# UNITED STATES PATENT AND TRADEMARK OFFICE

APPLICATION NO.	FILING DATE	FIRST NAMED INVENTOR	ATTORNEY DOCKET NO.	CONFIRMATION NO.
10/573,950	03/29/2007	Thomas Nissl	047956/307840	7925
37305	7590	09/27/2007		
ALSTON & BIRD LLP BANK OF AMERICA PLAZA 101 SOUTH TRYON STREET SUITE 4000 CHARLOTTE, NC 28280-4000			EXAMINER MILLER, CHERYL L	
			ART UNIT 3738	PAPER NUMBER
			MAIL DATE 09/27/2007	DELIVERY MODE PAPER

## **DETAILED ACTION**

# Attachment #1 (markedup)

Fig. 9

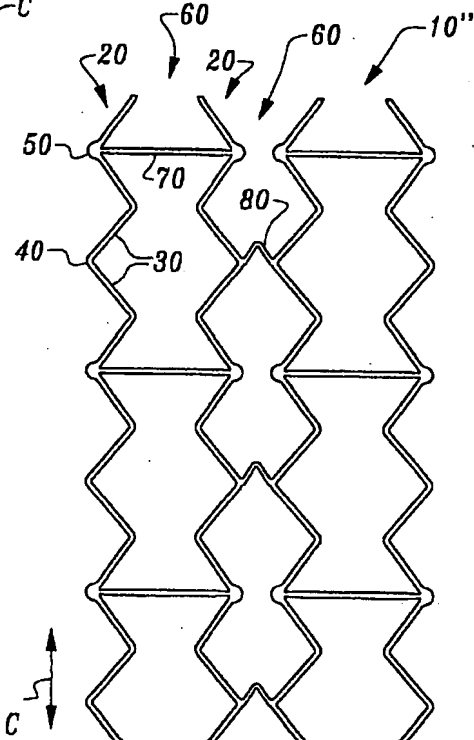
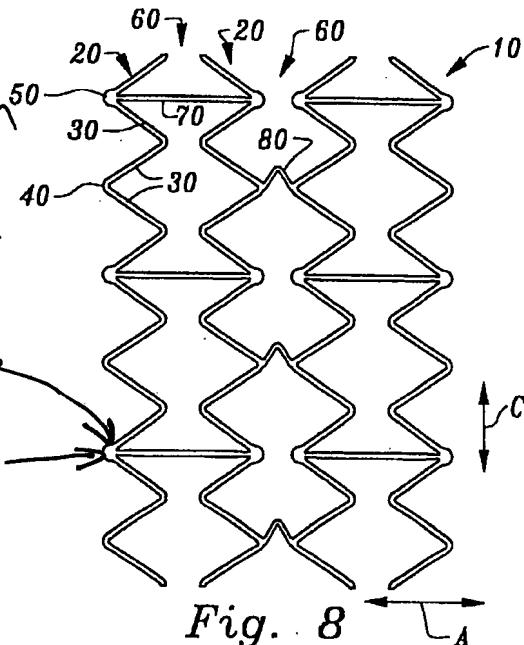
\* Throat region shown concave when expanded is support state.

Concave throat  
Convex head
